# Delegated Report

## Submission of Details Application

**Planning Application No:** 20240593

**Location:** Land To Rear Of 15 - 17 Darnley Road Gravesend Kent

#### Condition 9 (Soft Landscaping)

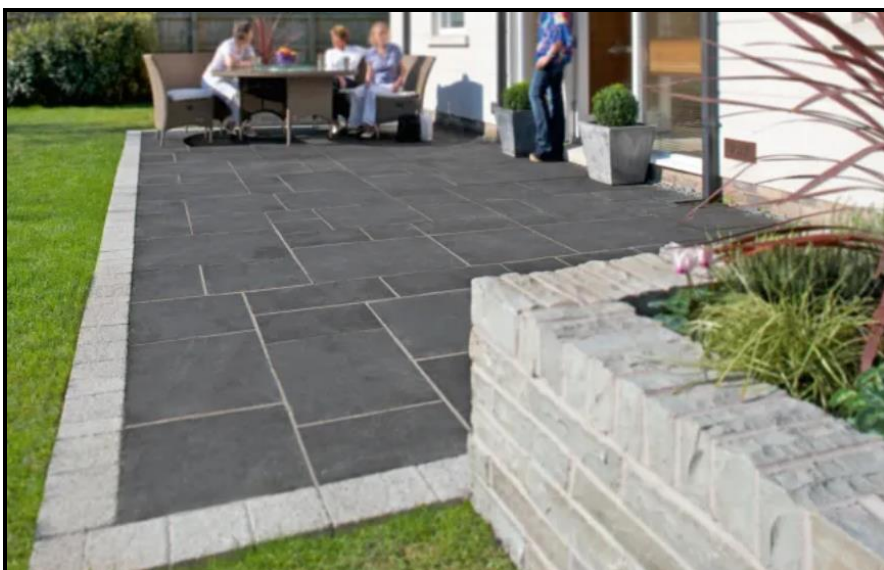
The soft landscaping details with this scheme include a planting mixture of Centaurea Cyanus, Viburnum Opulus, Geranium pratense and Lonicera periclymenum along the side of the building and front and side boundaries with a flowering lawn mix to the main lawn. These species are considered acceptable as native plants are used and would result in soft landscaping which would be visually appropriate. KCC Biodiversity have also found the details acceptable.
